Meeting Minutes – 11/5/14

Revised Cooling Section

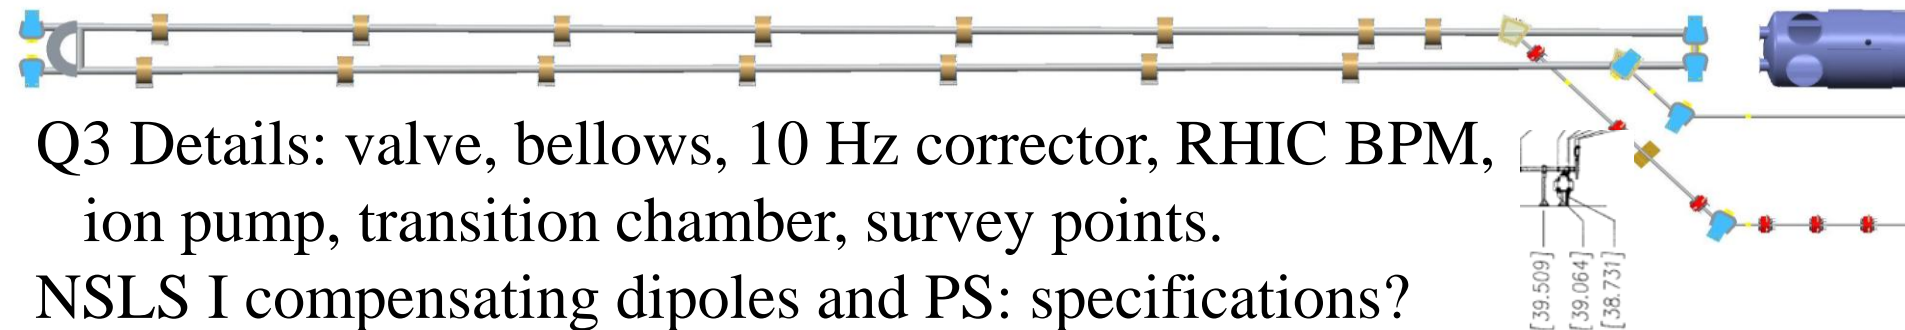
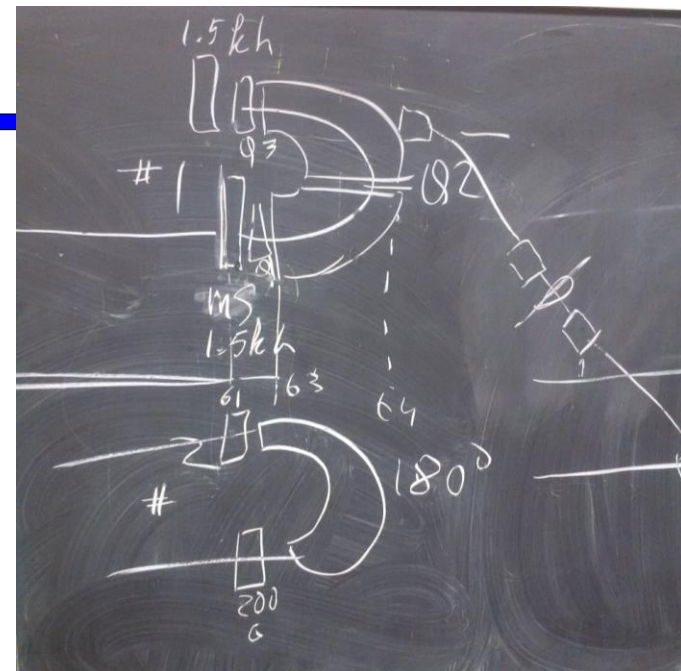
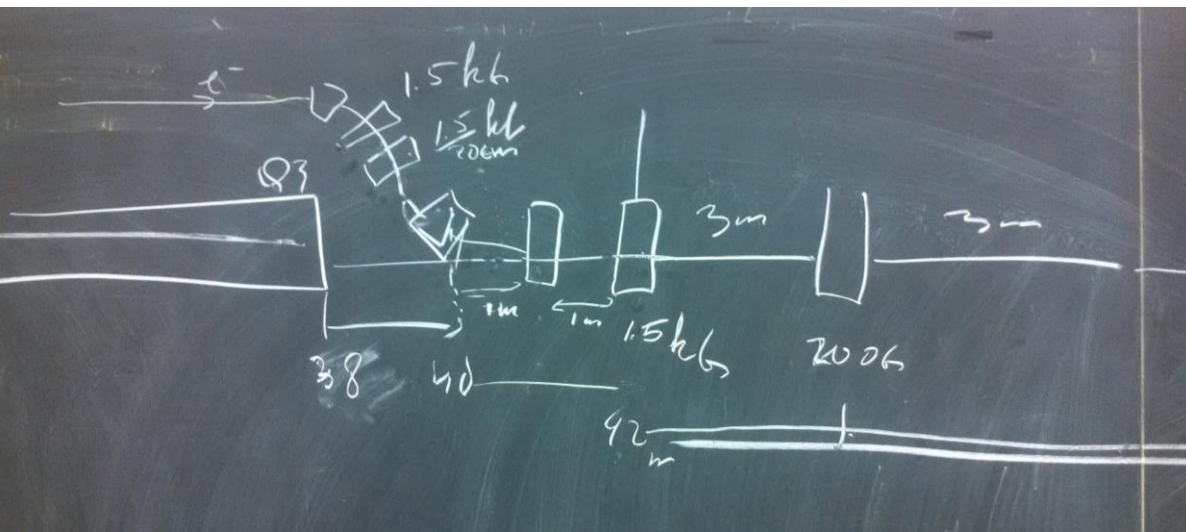
- Beam line design near Triplet magnet. G. Whitbeck needs details in this area to develop the design.
 - M. Mapes said the a shorter bellows may be used since there as other short bellows in the cooling section. Also, the conical adapter could be a part of the dipole chamber.

- There will still be an ion pump cross at this location.
 - The existing BPM at the DX magnet will be used. D. Gassner to provide detail drawing to G. Whitbeck.

Q3 Details: valve, bellows, 10 Hz corrector, RHIC BPM, ion pump, transition chamber, survey points.

Compensating Solenoids

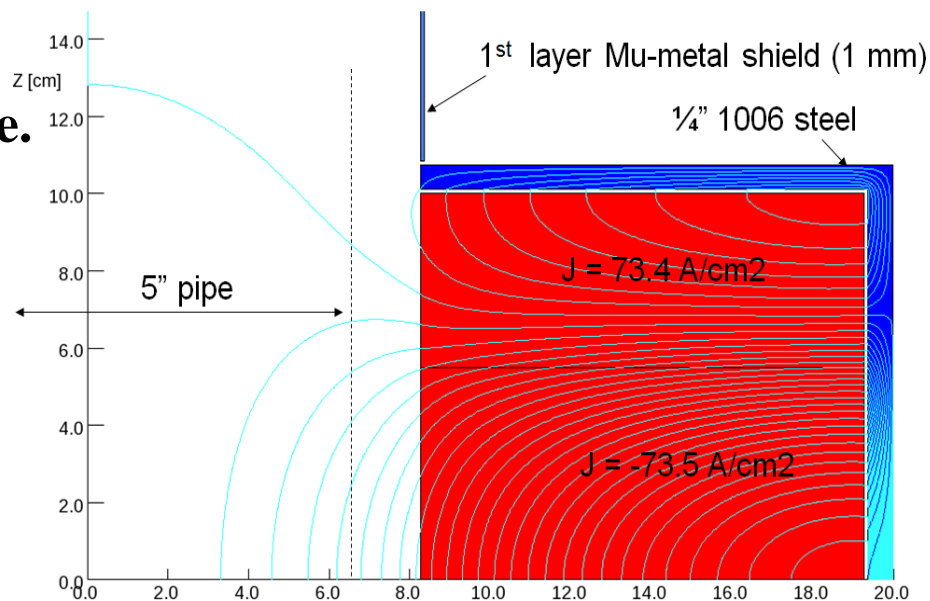
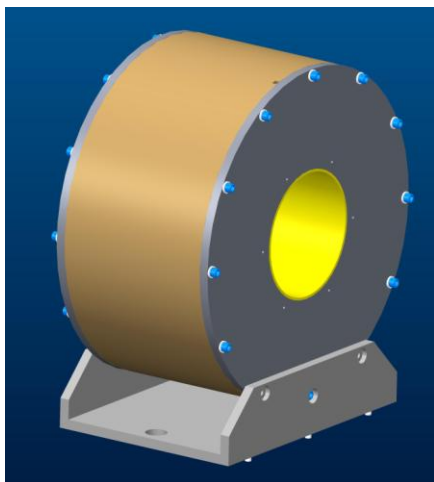
1. Compensating Solenoid: Presently based on W. Meng's design for 0.20kG with bucking coils.
2. Compensating Solenoid : The separate leads for the bucking solenoid coils and the main solenoid coil on the magnet assembly terminal block.
3. Compensating Solenoid Power Supplies: It has not been determined whether each solenoid will require 1, 2, or 3 power supplies.
4. Spacing: Compensating solenoids will be spaced 3 meters apart.

What is the $\int B_z dz$ for the 5 MeV case which you used?

My estimate that we would need maximum: $3e5 \text{ Gauss}^2\text{cm}$

Wuzheng has $3.4e5$ for the full integral which seems sufficient.

Cooling Section BPM's

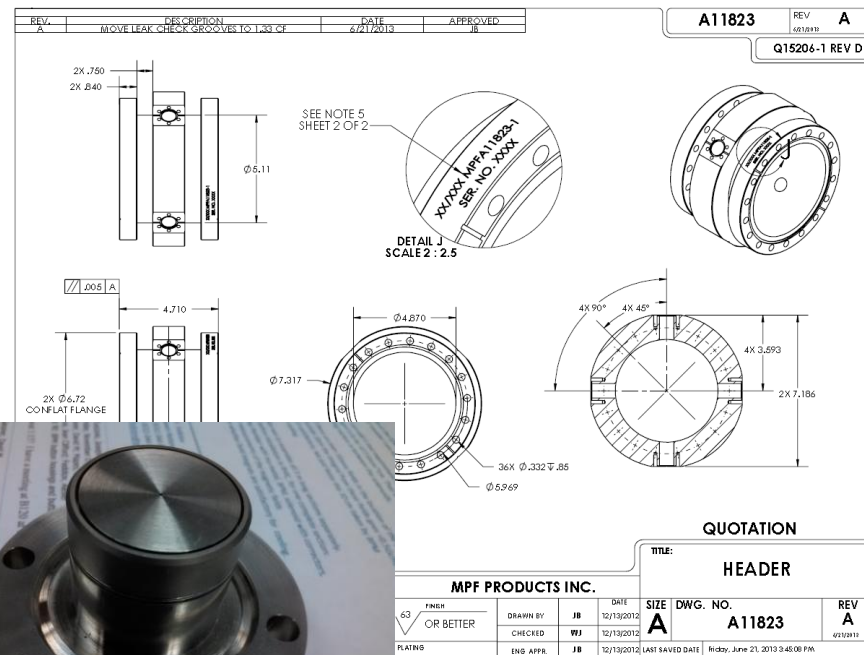
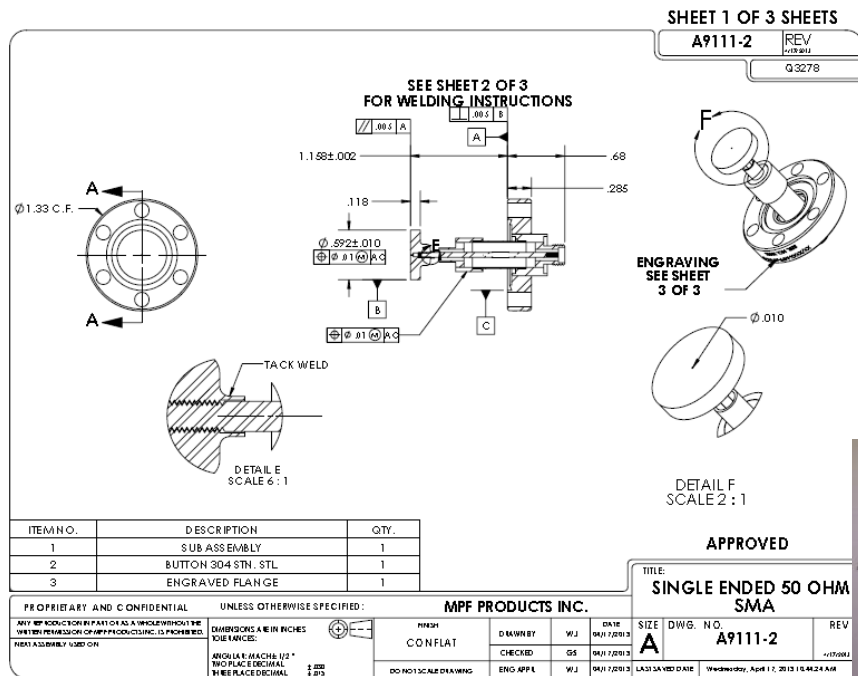
- Phone conference with MPF
- Larger diameter buttons on pick-up – 27 to 30 mm diameter
- Machined vacuum chamber, 304L, no threaded holes on flanges.
- Button hole size TBD microwave studio (D. Gassner).

Compensating Solenoid Corrector

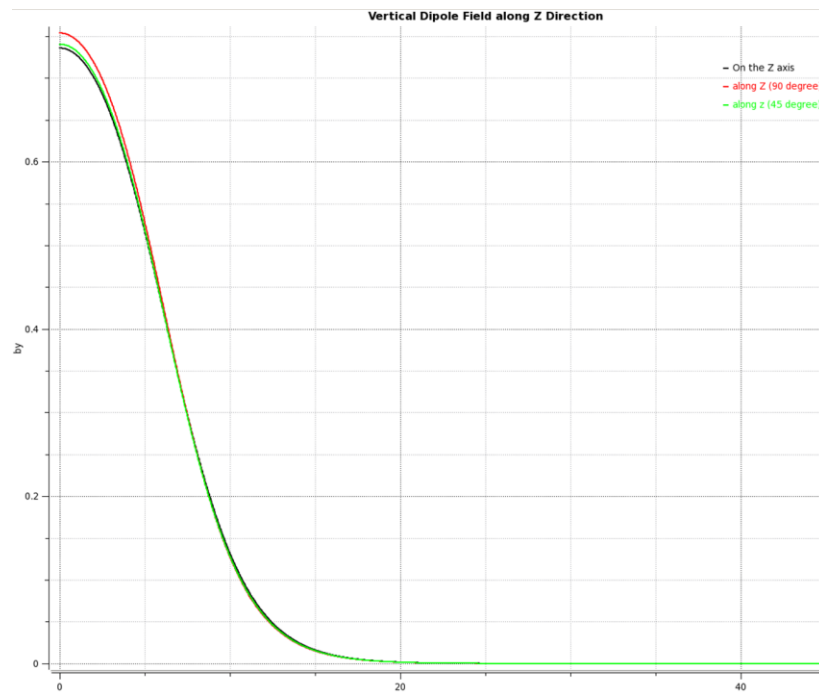
Dipole correction 10.24 A-T
Per coil; Straight section
Half-length: $H1=6$ cm
13 turns/.8 amps = 1 amp PS
(AWG #18 = 0.98 A/mm²)

Matching Solenoid w/corrector

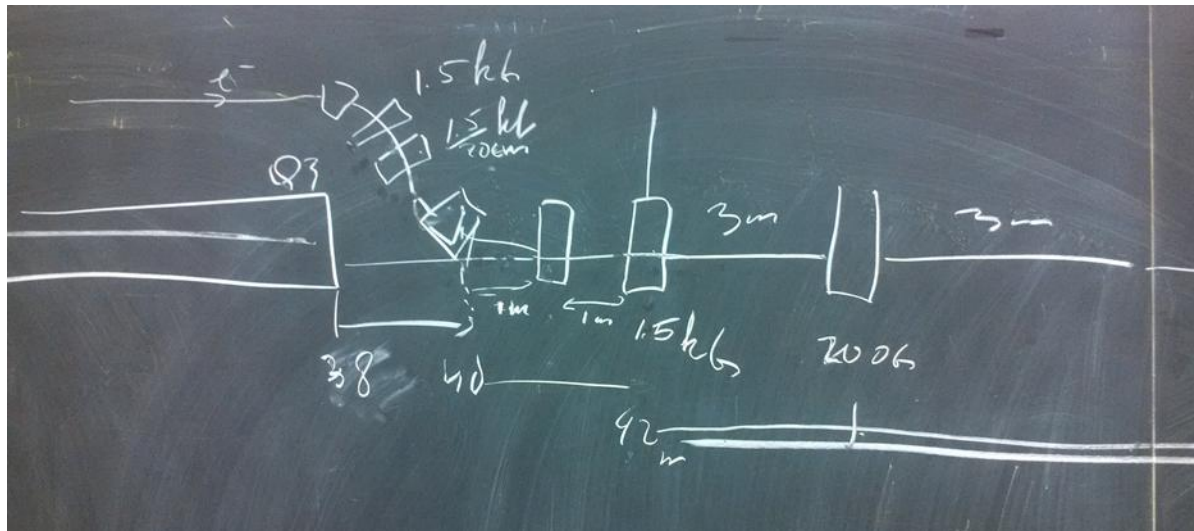
- 1.5 kG, magnetic length??
- Water cooled
- 2 required in cooling section w/bucking coil

(Need to look at alternatives to bucking coil: adjacent low field solenoid?)

- 2 required in cooling section w/o bucking coil
- Corrector 100 Gcm, present specification.

Push pull ERL approach: possible new baseline

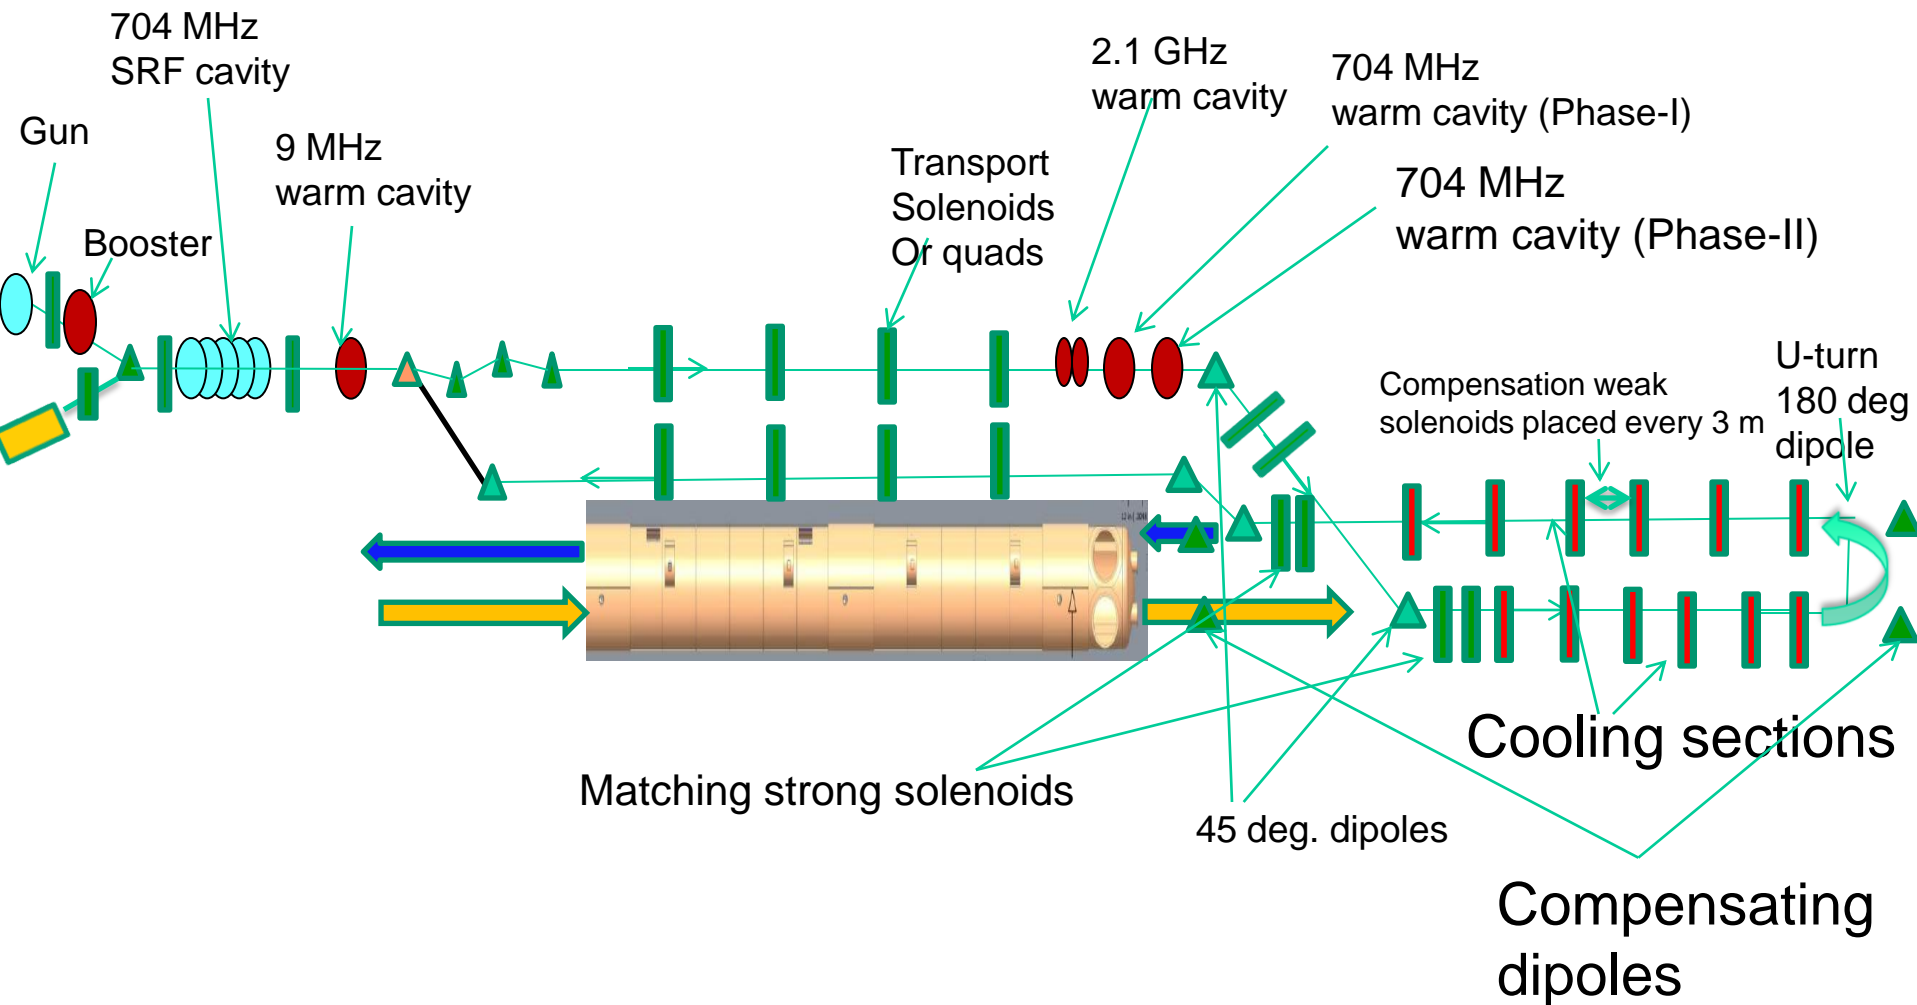
Note: Per email - G. Mahler on 11/13/14: “If we are considering cutting the transport line back and dumping locally, we should flip the layout.” See attached sheet.
